Awel y Môr Offshore Wind Farm

Application Errata List (Tracked)

Deadline 8

Document Reference: 8.39

FIGURE NUMBER:
Figure 1

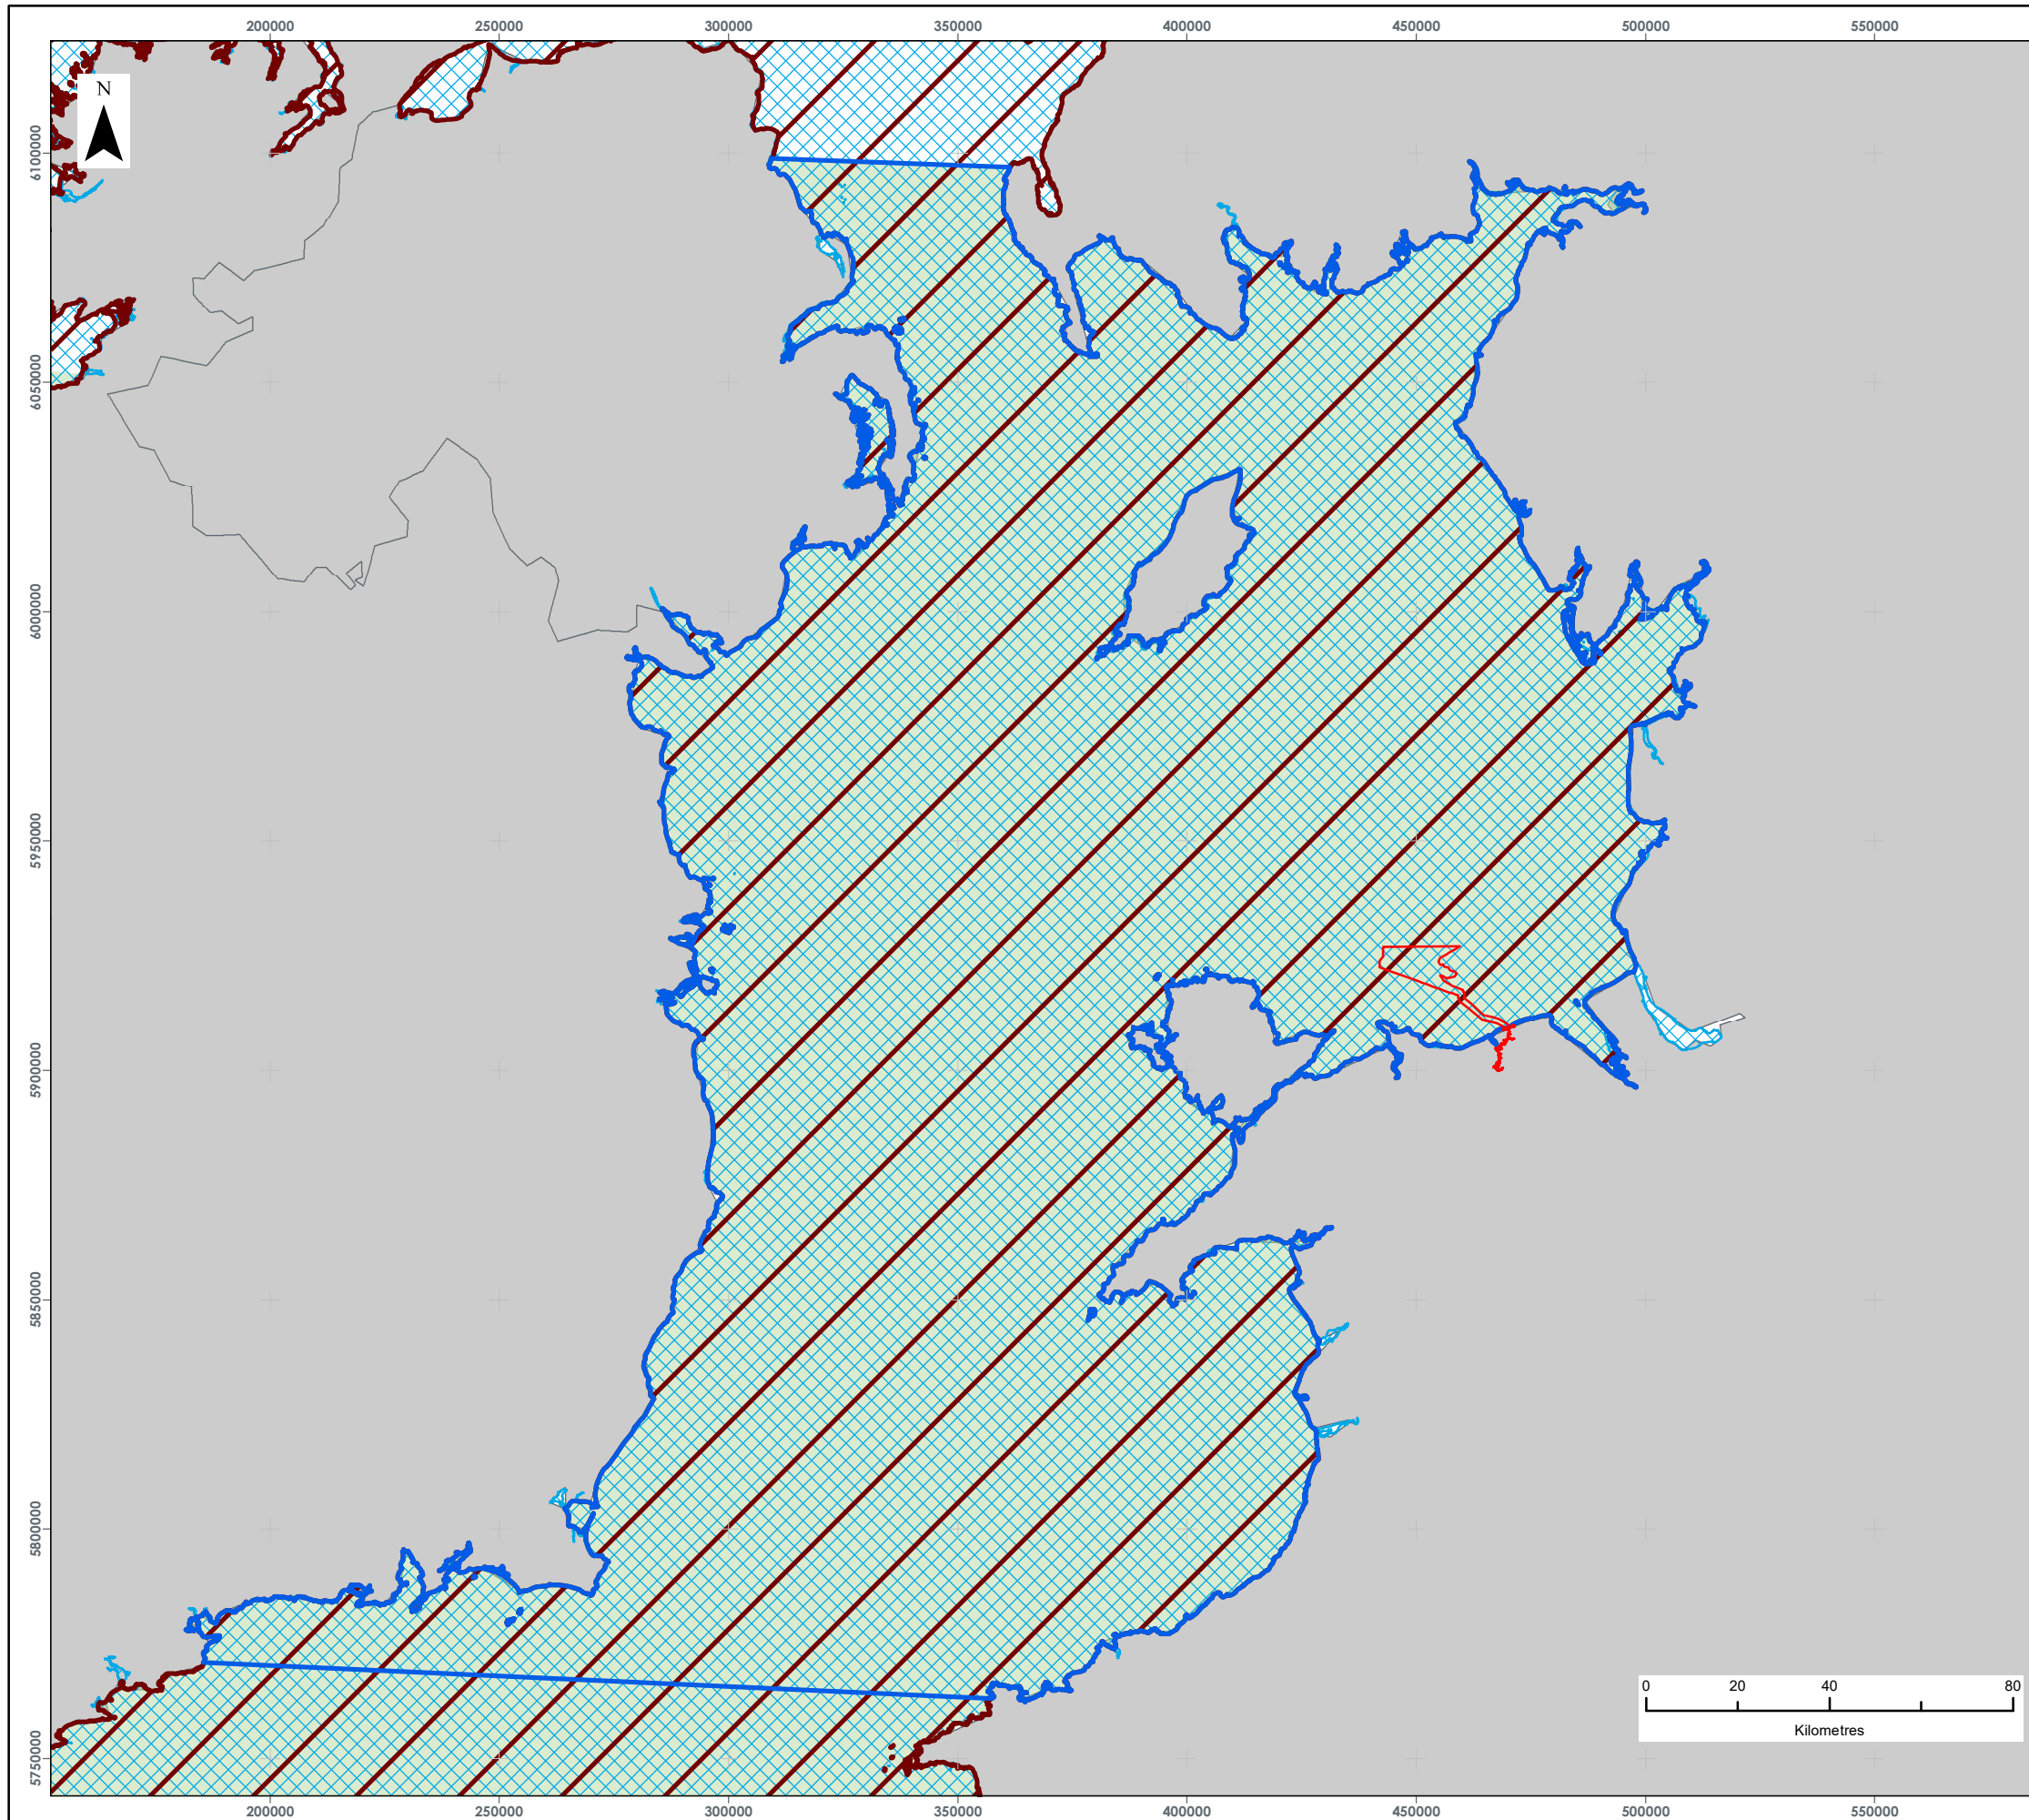
- ▲ Figure 1: Figure incorrectly displayed a black background and omitted base mapping. Corrected figure provided in Appendix A of this document. Note this figure is identical to Figure 1 presented in APP-053.

78 For completeness, the correct figures are appended to this document in Appendix A, duplicated from the figures presented in APP-053:

FIGURE NUMBER:
Figure 2

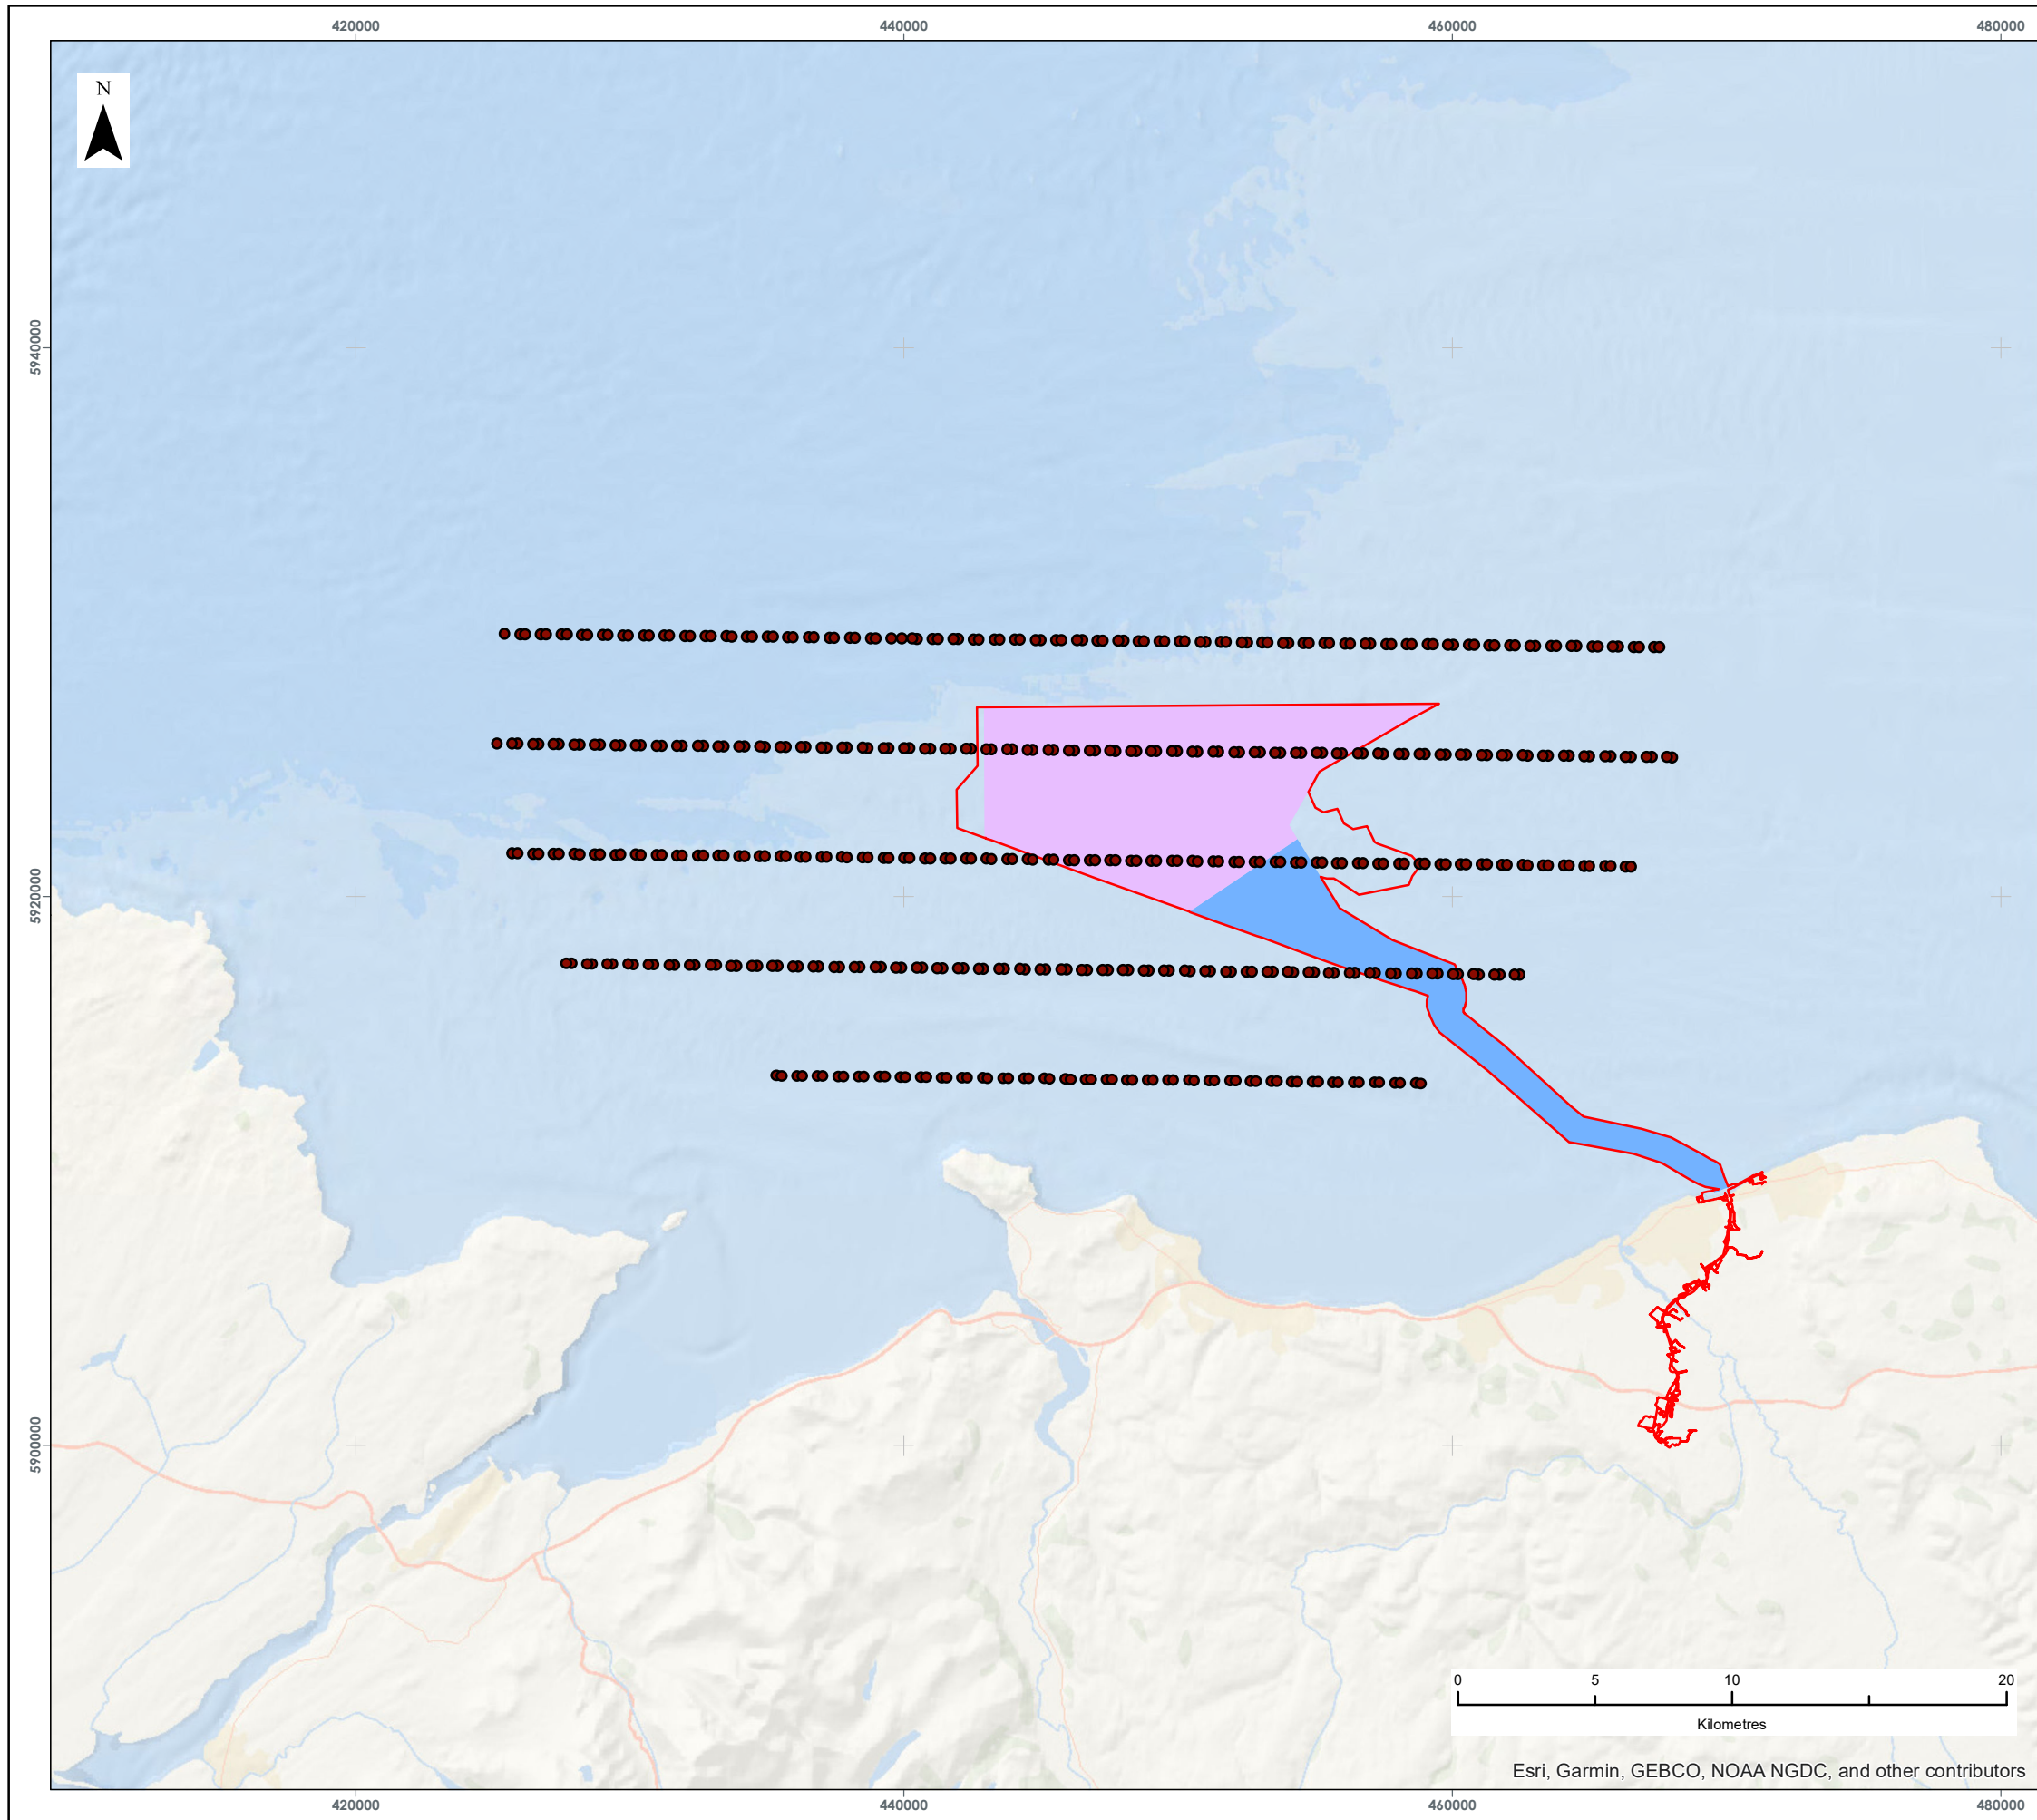
- ▲ Figure 2: Figure incorrectly displayed a black background and omitted base mapping. Corrected figure provided in Appendix A of this document. Note this figure is identical to Figure 2 presented in APP-053.

FIGURE NUMBER:
Figure 18

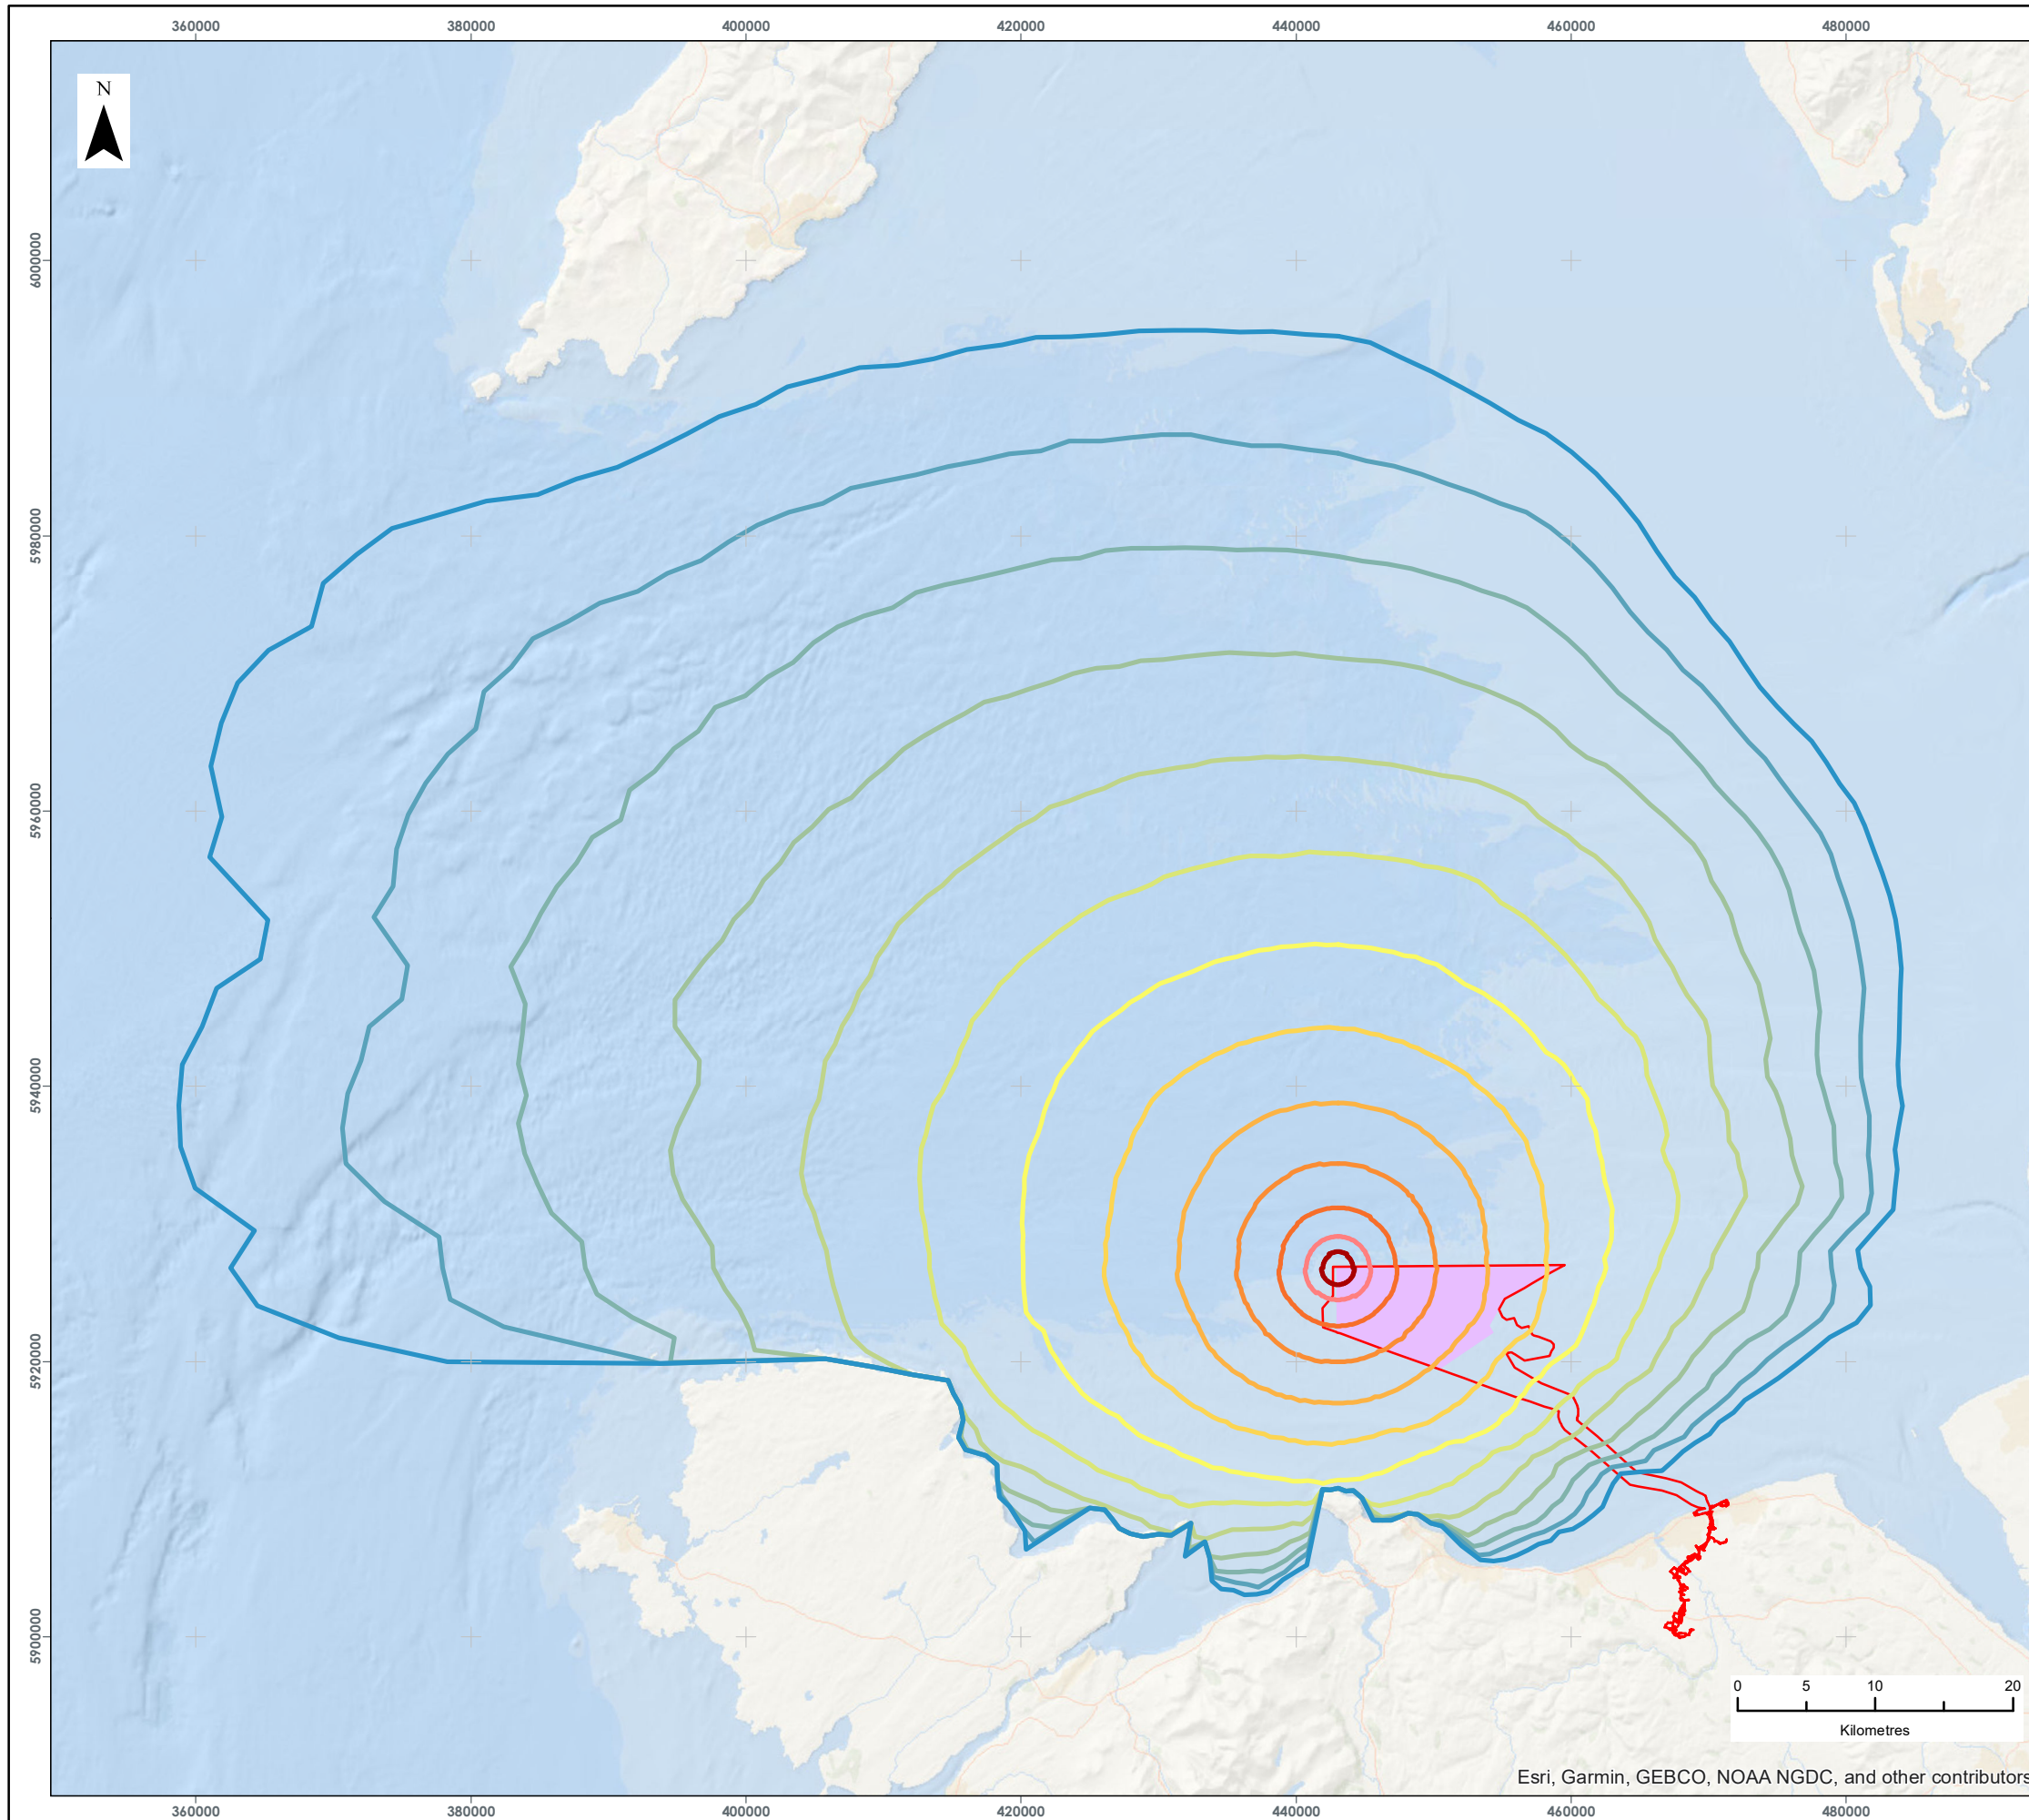
- ▲ Figure 18: Figure incorrectly displayed a partial black background and omitted base mapping. Corrected figure provided in Appendix A of this document. Note this figure is identical to Figure 18 presented in APP-053.
